**IN THE TITLE**

Please amend the title of the invention as “Sequence Lighting System for Footwear”

## REMARKS

**FIG.1**

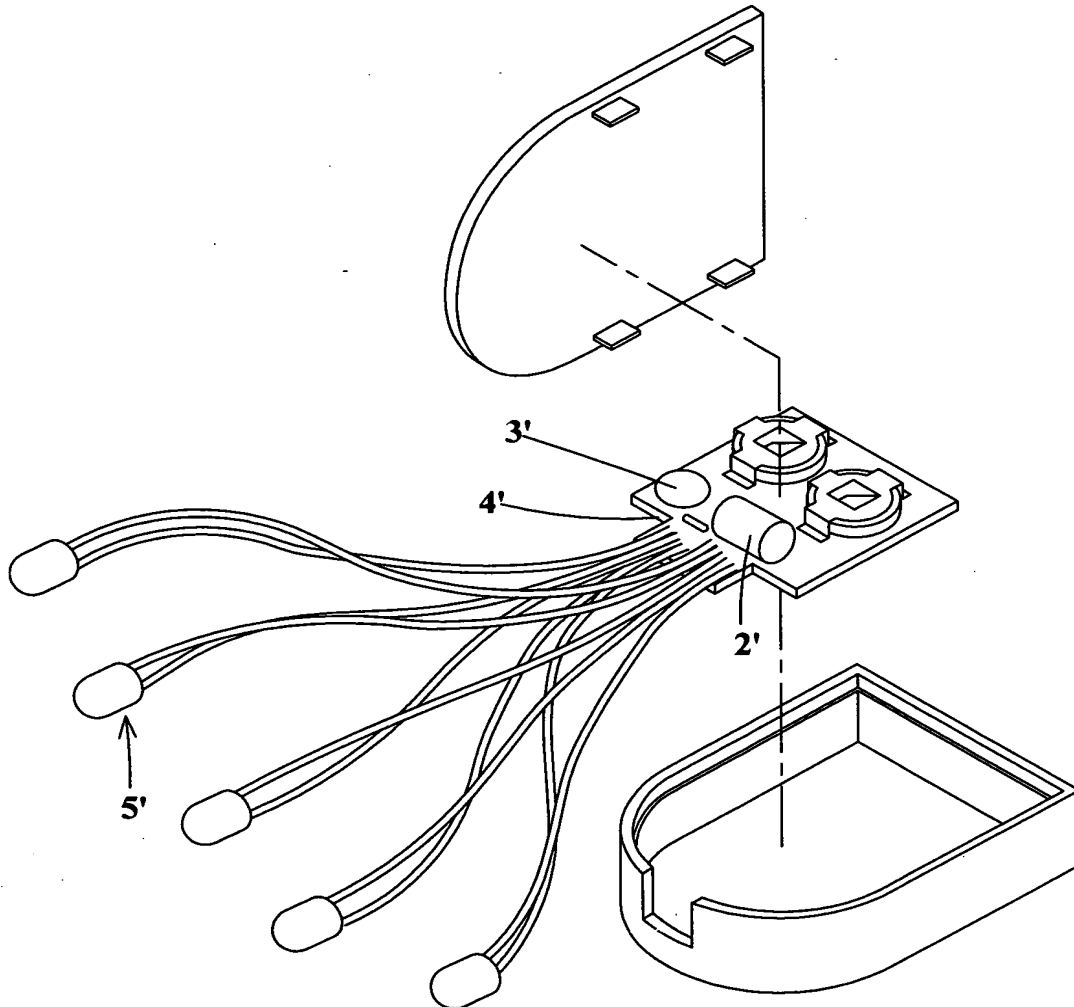
Please amend the Fig. 1 as the attached amended copy. In the amendment of the figure, the figure is added with “Prior Art”. No other portion is amended. Thereby, no new matter is added.
